Docket Number:	03-AFC-02C
Project Title:	Los Esteros Phase II Compliance
TN #:	234382
Document Title:	Statement of Staff Approval of Proposed Change
Description:	N/A
Filer:	Cenne Jackson
Organization:	California Energy Commission
Submitter Role:	Commission Staff
Submission Date:	8/20/2020 8:54:33 AM
Docketed Date:	8/20/2020

STATEMENT OF STAFF APPROVAL OF PROPOSED CHANGE

POST-CERTIFICATION PROJECT CHANGE LOS ESTEROS CRITICAL ENERGY FACILITY (03-AFC-02C)

Air Quality Figure 1
LECEF Total Sulfur Content Results

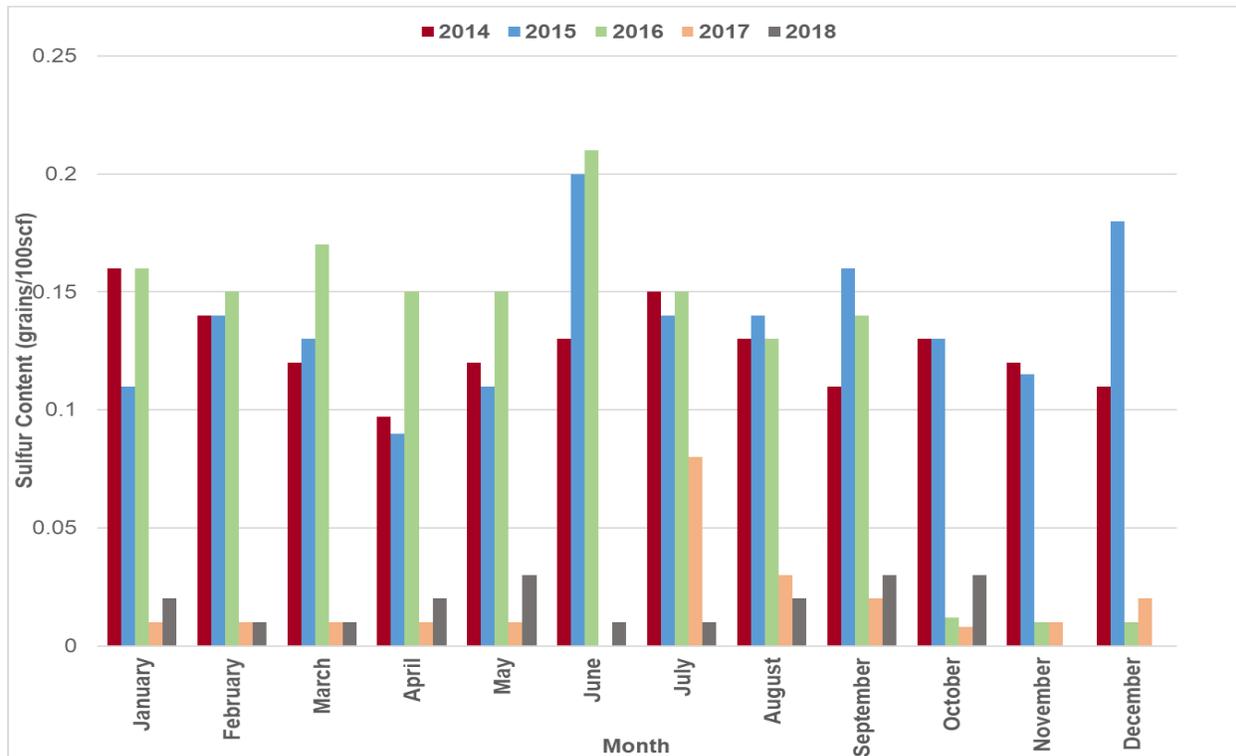
Air Quality Figure 1 shows the total sulfur content of the fuel used at the facility. The results from years 2014 to 2018 were reported on a monthly frequency as required by the condition of certification. Over the most recent five years of testing results reported, all sampling results have been below the total sulfur content limit of 1.0-grain (gr) sulfur/100 standard cubic foot (scf).

Onsite results for sulfur show a good correlation between sulfur content of gas measured by the facility onsite and system average values. Staff recommends allowing LECEF to use a system average value to report sulfur content of the gas they use. However, during source tests, LECEF must measure onsite sulfur content.

- Modify **AQ-24(b)** to allow for use of quarterly sulfur data obtained from PG&E's website, except during source tests.
- Delete language in **AQ-26(a)**, **AQ-26(b)**, **AQ-27**, **AQ-45**, and **AQ-47** that relates to initial startup.

Air Quality Figure 2
PG&E Total System-Wide Average Sulfur Content Results

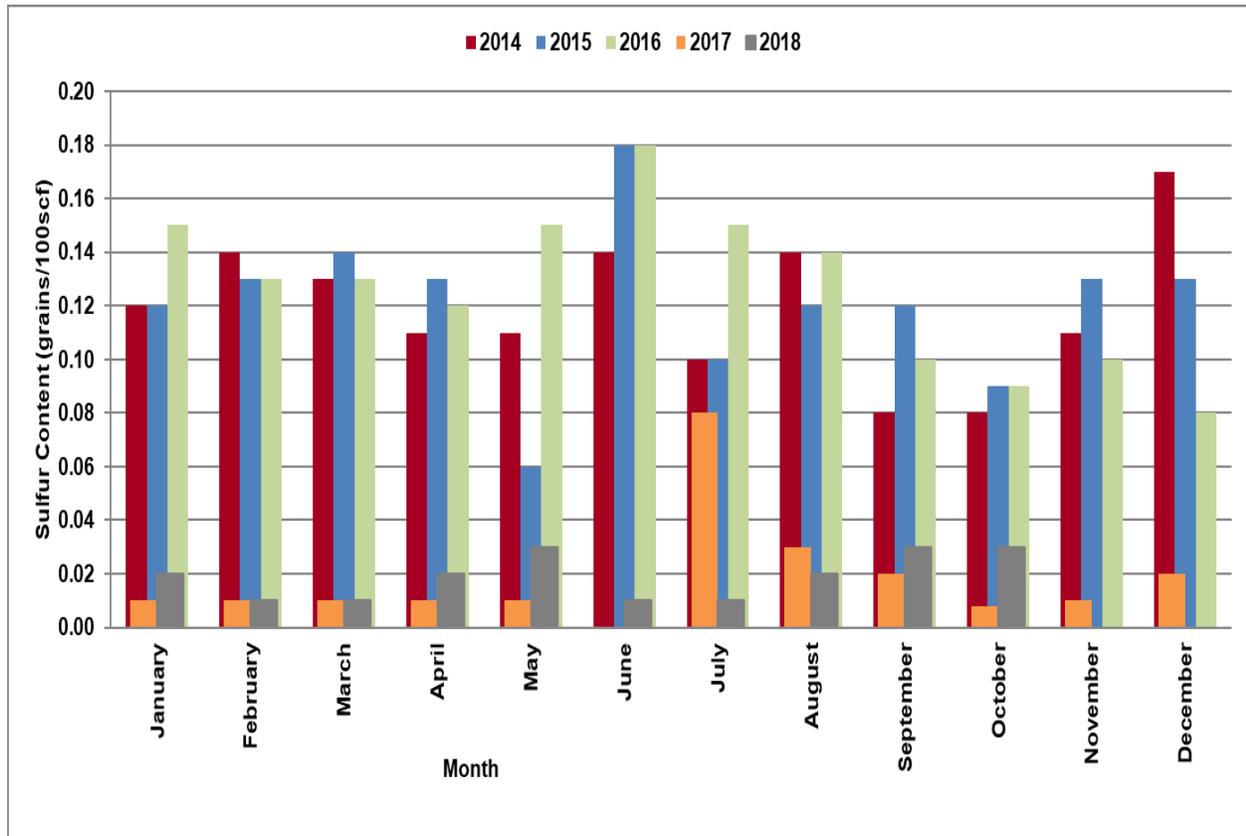
Air Quality Figure 2 shows the total sulfur content of natural gas system-wide for PG&E's monthly average results. PG&E measures sulfur at more than eleven locations in the Bay Area using online sulfur chromatographs. PG&E reports an average and a high value for each quarter. PG&E is allowed to have a maximum of no more than 1.0-grain sulfur/100 scf of gas, but the system-wide average is usually less than 0.25 grain sulfur/100 scf of gas as shown in **Air Quality Figure 2**. PG&E reports an average and a high value for each quarter.

The highest level reported since 2006 was 0.713-grain sulfur/100 scf of gas for the third quarter of 2009, below the maximum allowed, which is 1.0-grain sulfur/100 scf. PG&E displays the reported maximum values and system average values on their online database.
